#### NATIONAL HYDROGRAPHIC CENTRE Royal Malaysian Navy

### MALAYSIAN NOTICES TO MARINERS

#### Monthly Edition 5 of 2014 31 MAY 2014

Chart WAL 4506 (Last Correction 38/2014) WGS 84 DATUM

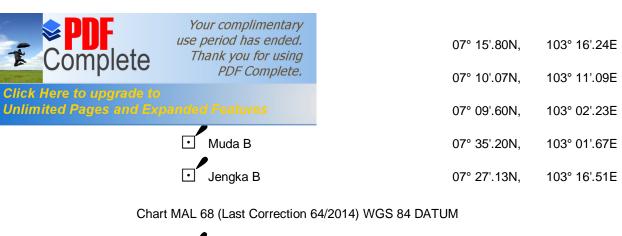
Insert	depth, 30, encloced by 30m contou	ır <i>(a)</i>	12° 32′.60N,	120° 38′.90E			
Delete	depth, 66, close S of:		(a) above				
81/201	4* Malaysia - Perak - Lumut - Sung	- Wreck.					
	Source: National Hydrographic Centre,	Royal Mala	ysian Navy.				
	Chart MAL 5416 (Last Correction 181/2013) WGS 84 DATUM						
Insert	<b>(#</b> )		04° 14′.31N,	100° 38'.27E			
82/201	l4* Malaysia - Melaka - Sungai Udar	Malaysia - Melaka - Sungai Udang - Obstruction.					
	Source: National Hydrographic Centre, Royal Malaysian Navy.						
	Chart MAL 521 (Last Correction 162/2013)	WGS 84 D	ATUM				
Insert	19 : Obstn		02° 10′.35N,	102° 12′.14E			
	Chart MAL 5217 (Last Correction 161/2013	3) WGS 84 [	DATUM				
Insert			02° 10′.35N,	102° 12′.14E			
83/201	South China Sea - Pulau-Pulau I Gas Field - Platform.	South China Sea - Pulau-Pulau Natuna Utara W and Central Luconia Gas Field - Platform.					
	Source: British Admiralty Notice No. 2079/2014.
